Re: Notification of Proposed Bringelly Road Warehouse and Distribution Facility (SSD-37558583)

Attachment – Detailed comments

Figure 2: View of the Business Hub from the east (Cowpasture Road). Source: Google Street View

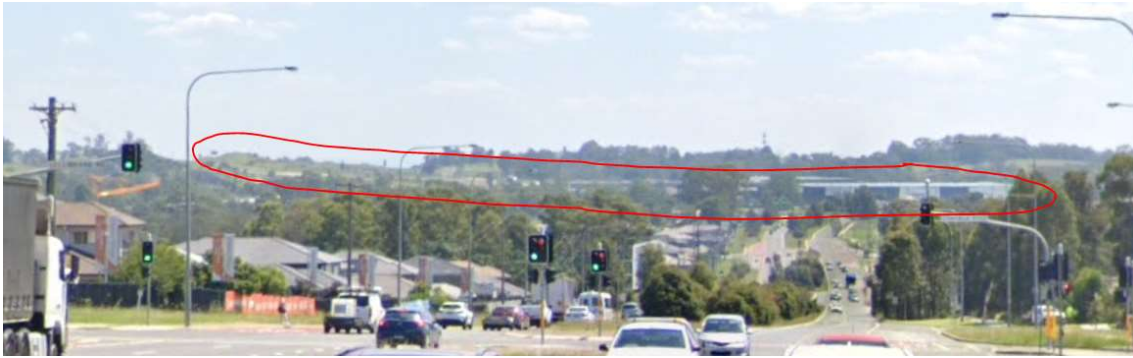
The proposed warehouse development is part of Bringelly Road Business Hub which is located at a visually prominent location within the Liverpool LGA. The position of the Business hub on a major ridgeline which traverses Western Sydney requires that the development demonstrates high quality design, given the far views to the site and the site's position as a gateway to the Western Sydney Growth Areas. The hub is also adjacent to residential developments at Horningsea Park, West Hoxton and Austral/Leppington. Due to its unique location, views and proximity to residential areas, the site requires high visual amenity and quality urban design (refer to *Figures 1 to 4* - for existing views of the site).
